REGIONAL REVIEW NOTIFICATION

ARC REVIEW CODE: R1711081

Name of Proposal: MAC IV – Derrick Road (DRI 2737)

MAC IV – DERRICK ROAD DRI
City of Union City
Natural Resources Division Review Comments

PRELIMINARY
SITE PLAN

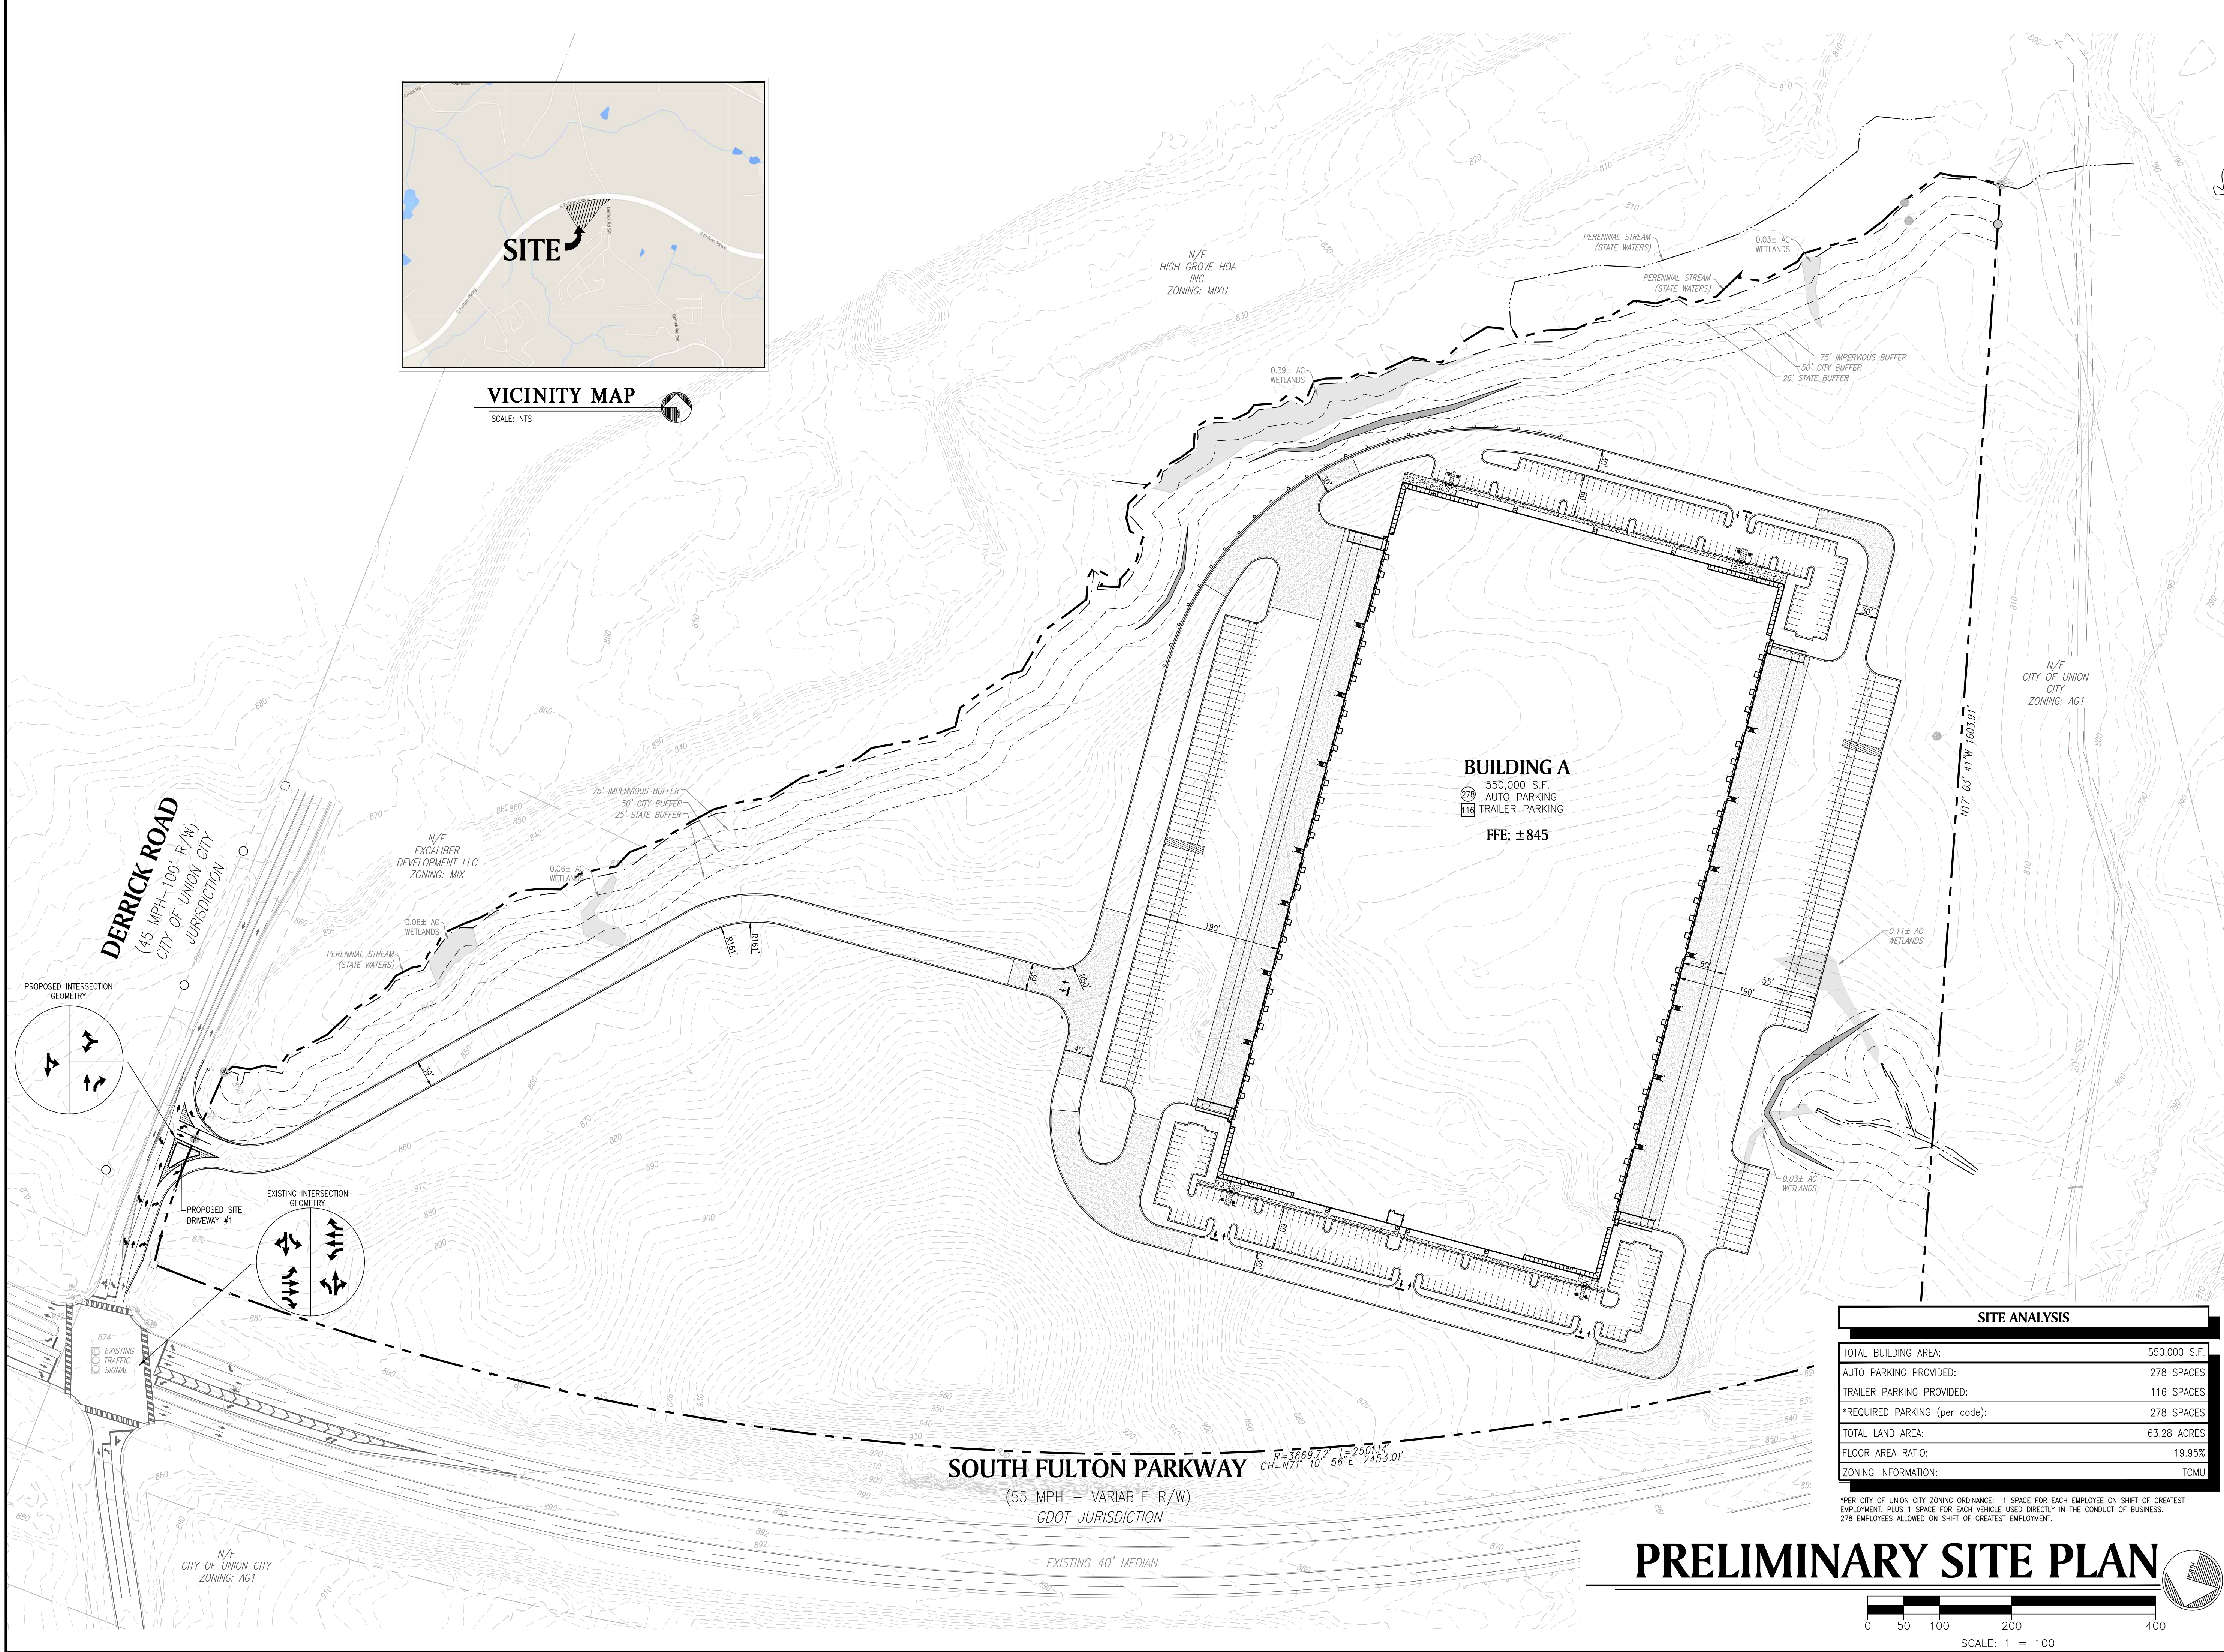
The USGS coverage for the project area shows no blue line streams on or near the project property. However, the site plan shows a perennial stream running along the southern boundary of the property and the headwaters of a stream on the west side of the project property. The City's 50-foot stream buffer and 75-foot impervious setback as well as the state 25-foot erosion and sedimentation buffer are shown along both streams, and no intrusions into any buffer are shown on the site plan. Any other waters of the state that may be on the property will be subject to the State 25-foot erosion and sedimentation buffer requirements.

The development site proposes a single building with a single looped driveway providing accessibility throughout the warehouse and distribution site. Surrounding land uses consist of single family residential development on the southern boundary and undeveloped property on the west. Although the Residential uses are not compatible uses for connectivity, the site plan precludes stub outs for future connectivity on undeveloped adjacent properties.

Pedestrian and bicycle facilities are not proposed as a part of development on this site.
